COPPERSTRING EIS

Attachment F - Vegetation Clearing Works plans

Flinders Substation to Dajarra Road Substation

FLR_DJR_98

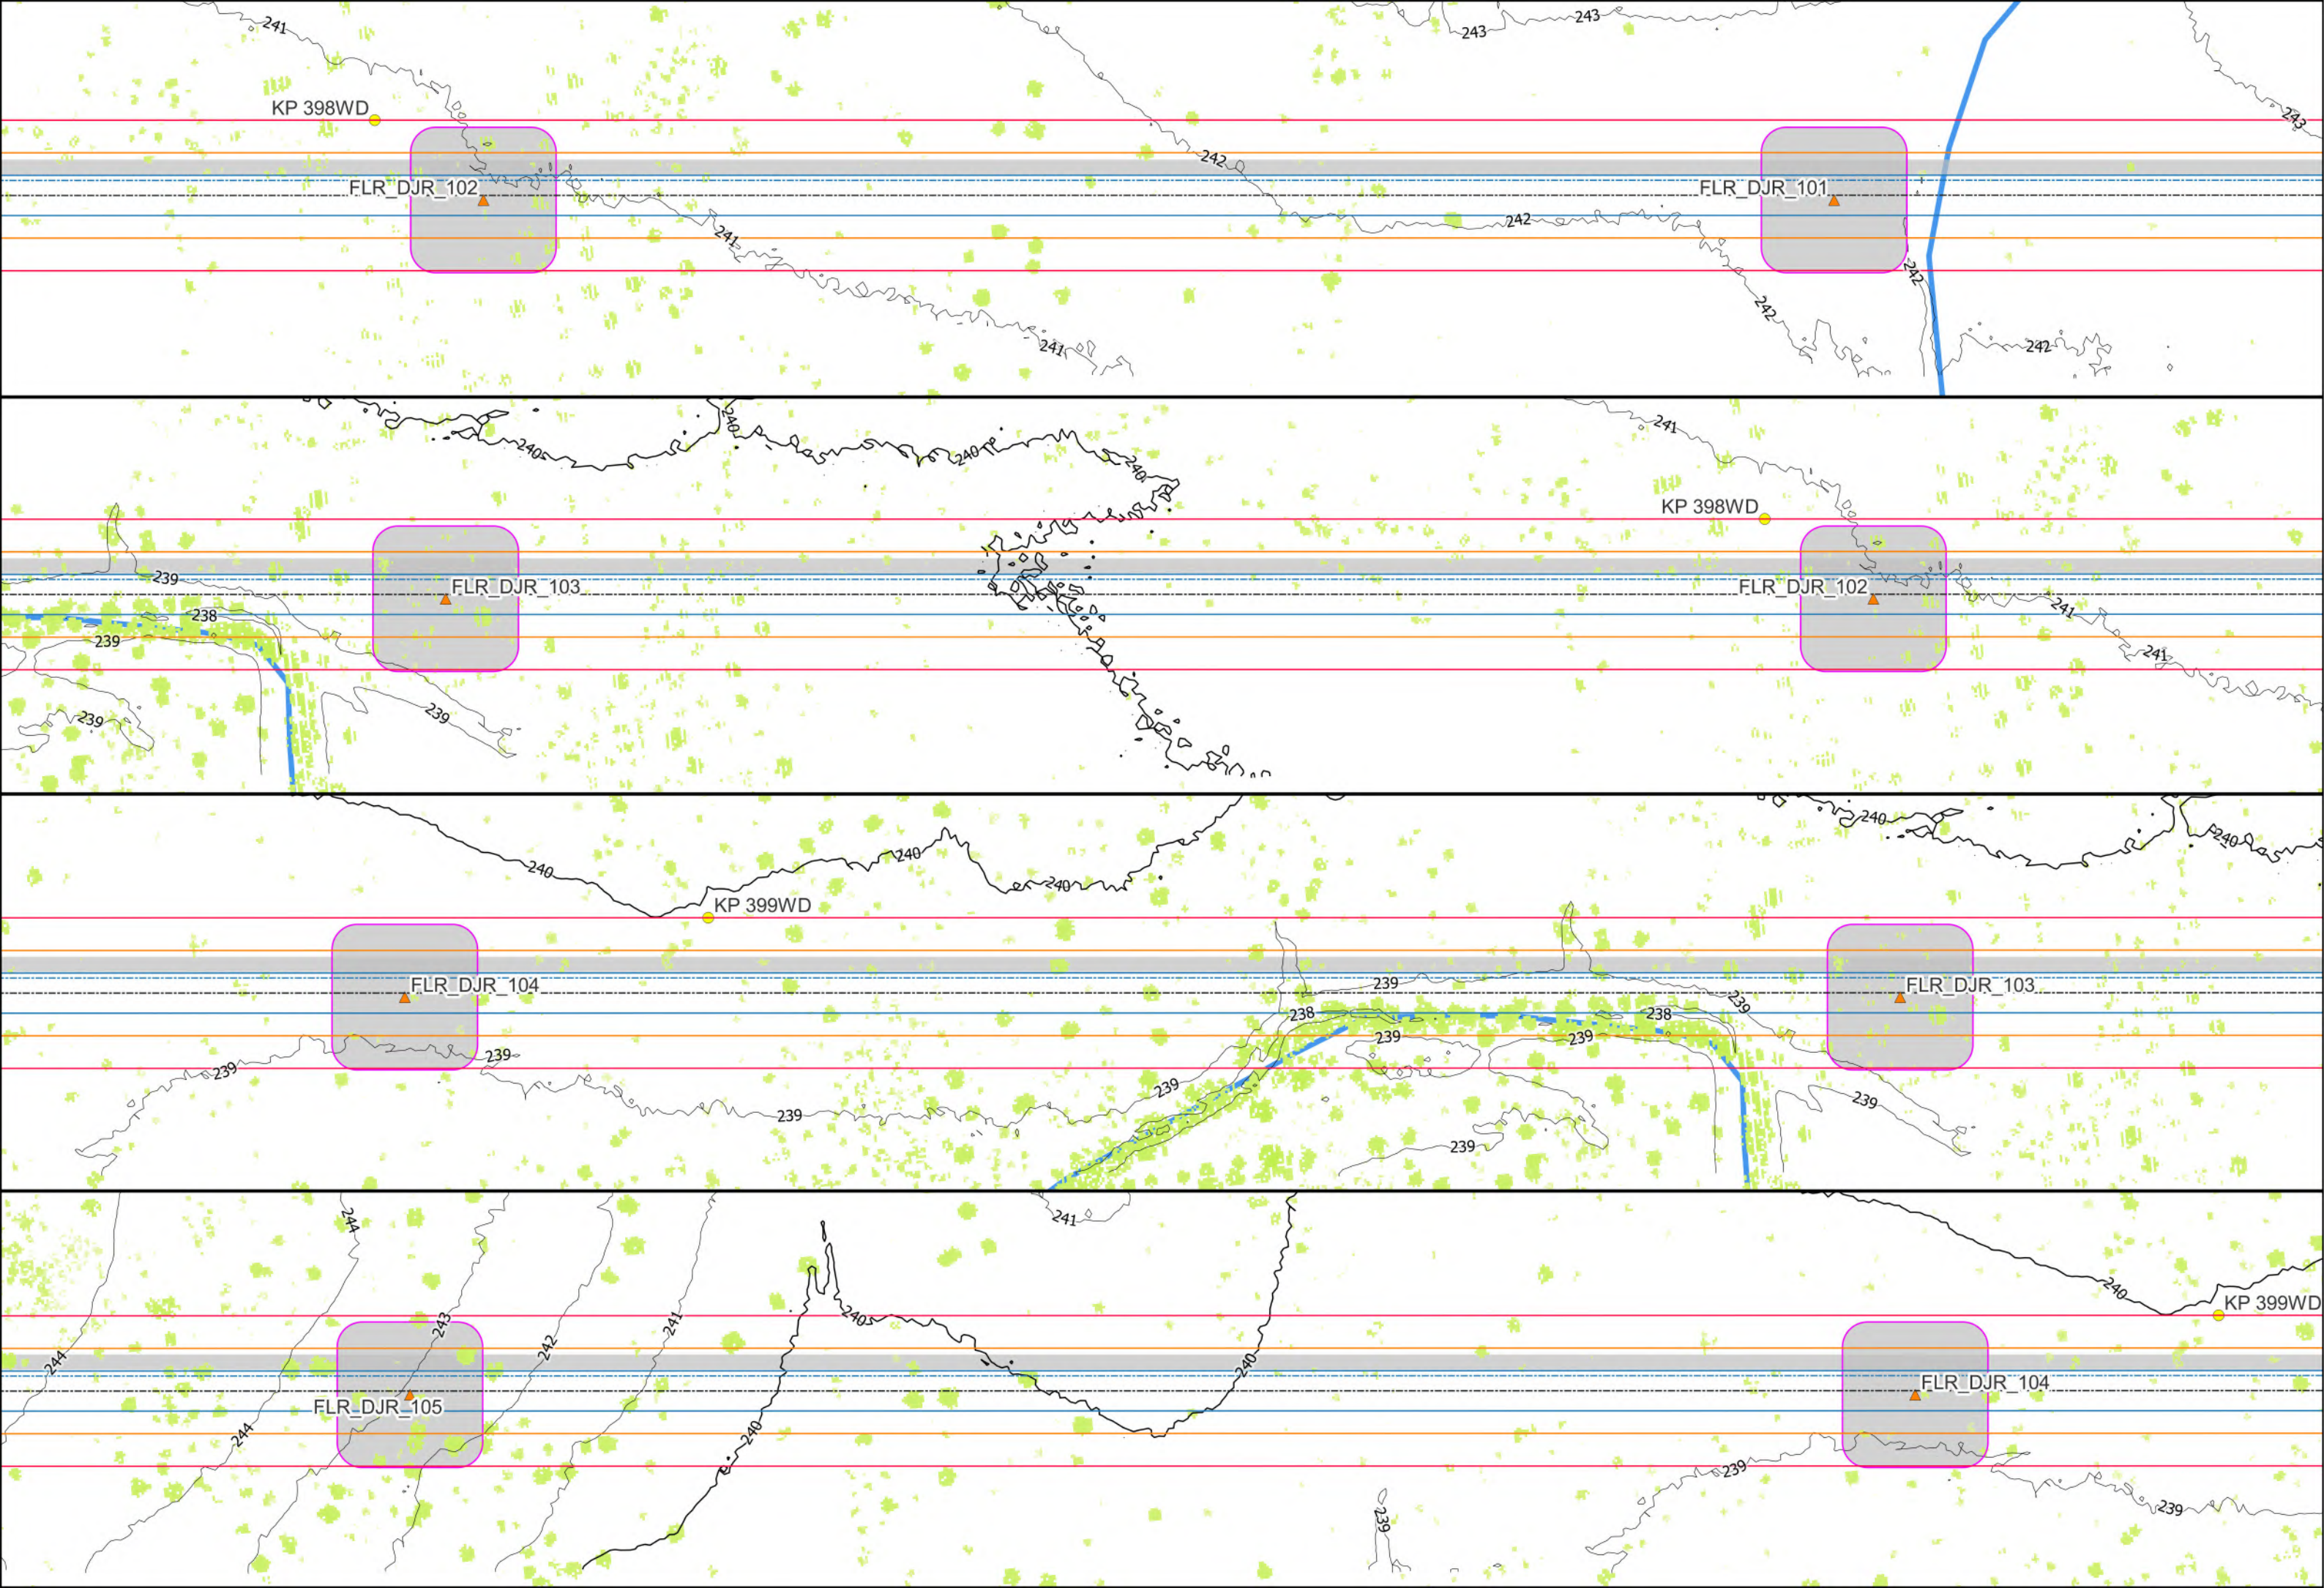
Tower assembly area to be reconfigured to not be within 15m of the high bank of waterway and to avoid clearing near or within the bed and banks for the waterway.

FLR_DJR_99

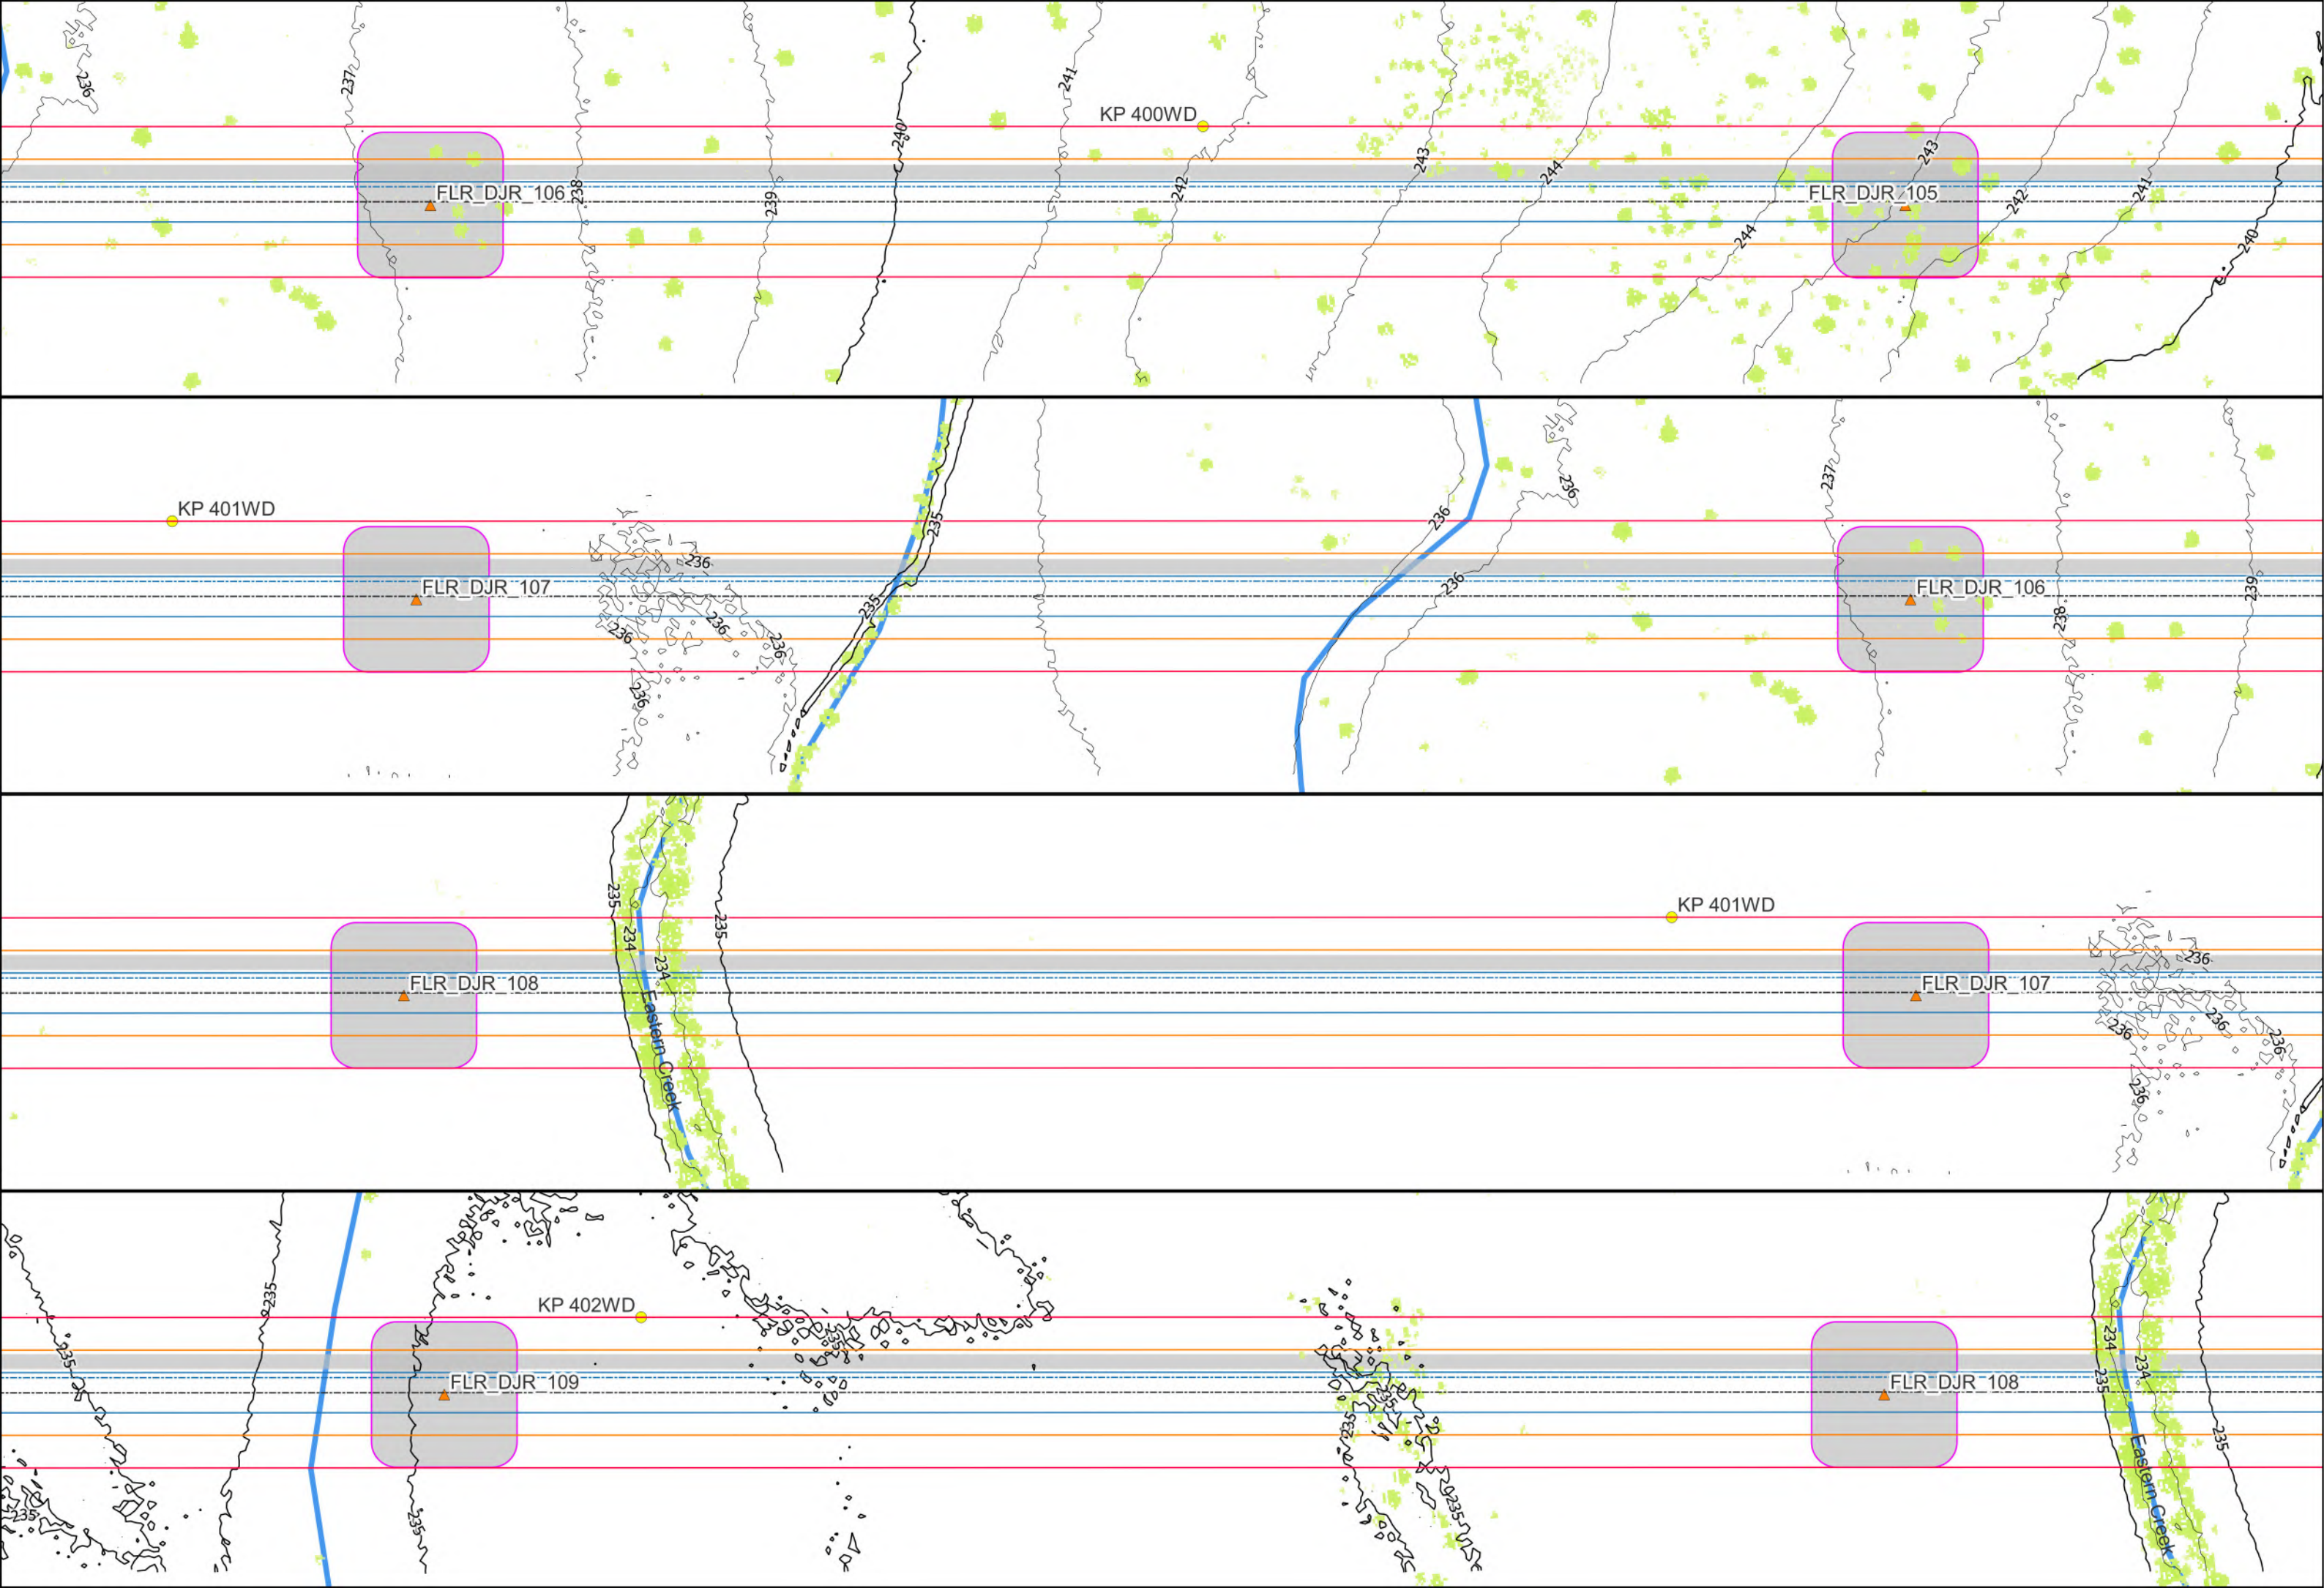
Tower assembly area to be reconfigured to not be within 15m of the high bank of waterway and to avoid clearing near or within the bed and banks for the waterway.

FLR DJR 114

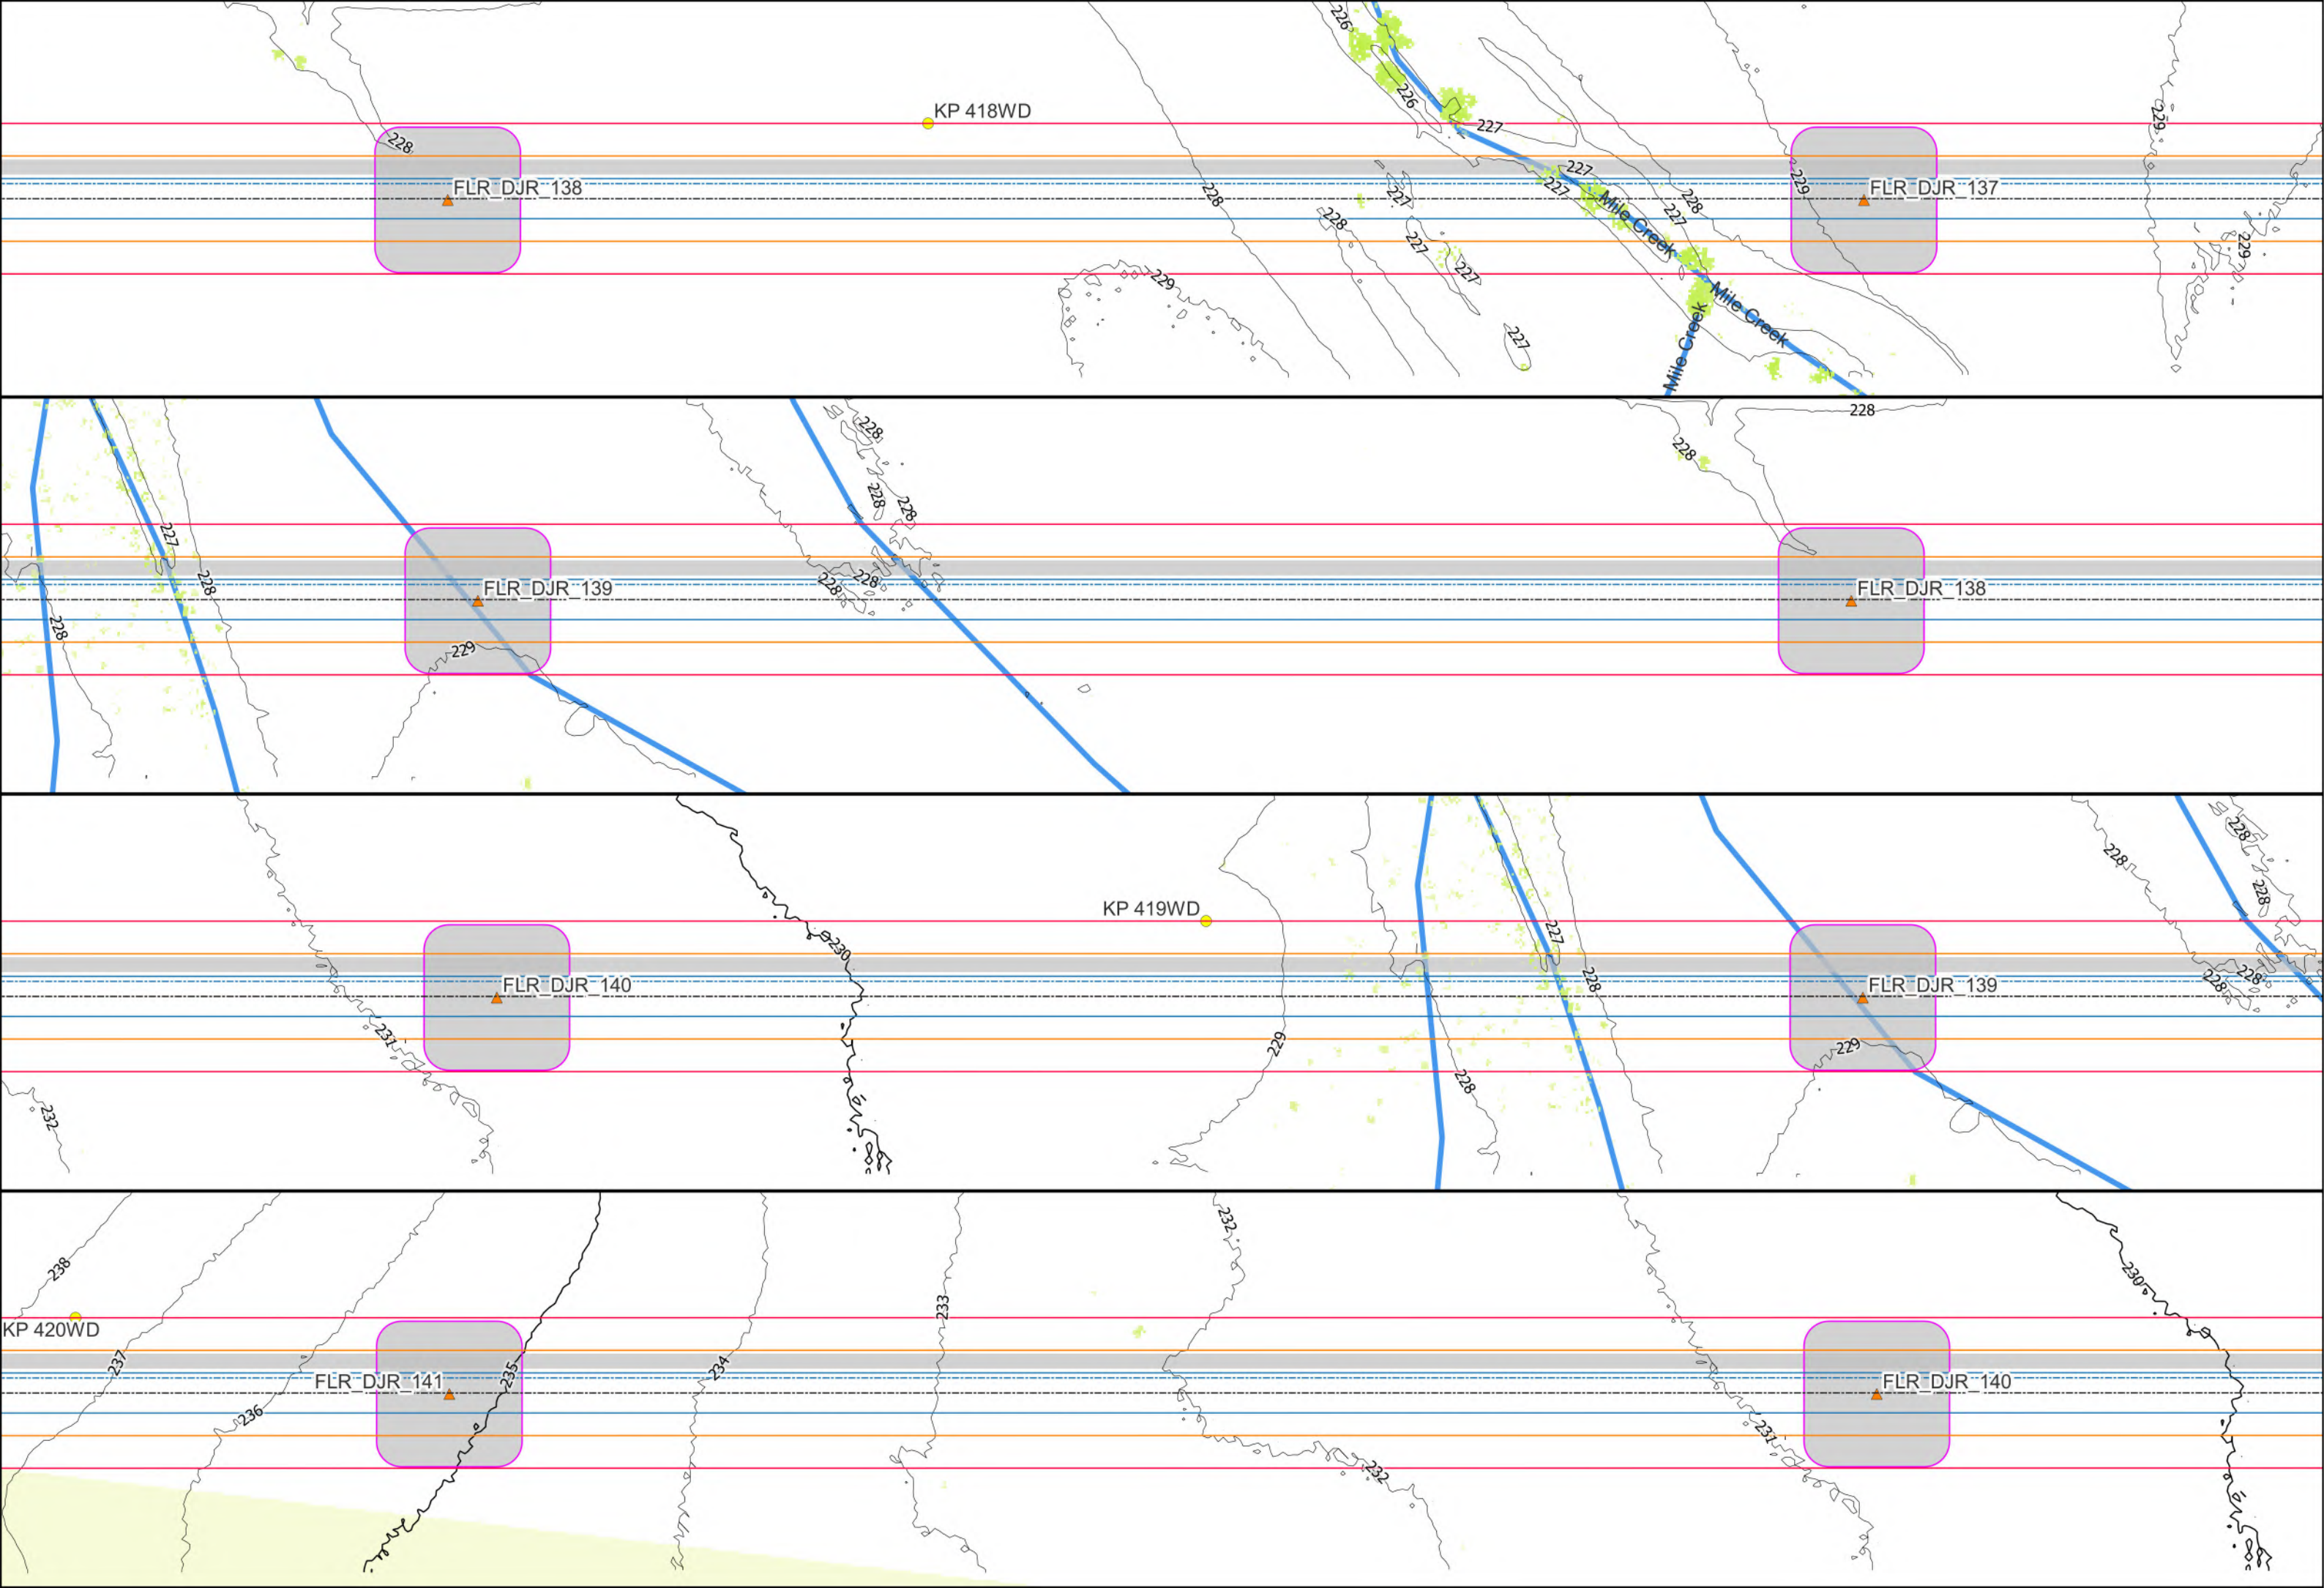
Tower assembly area to be reconfigured to not be within 15m of the high bank of waterway and to avoid clearing near or within the bed and banks for the waterway.
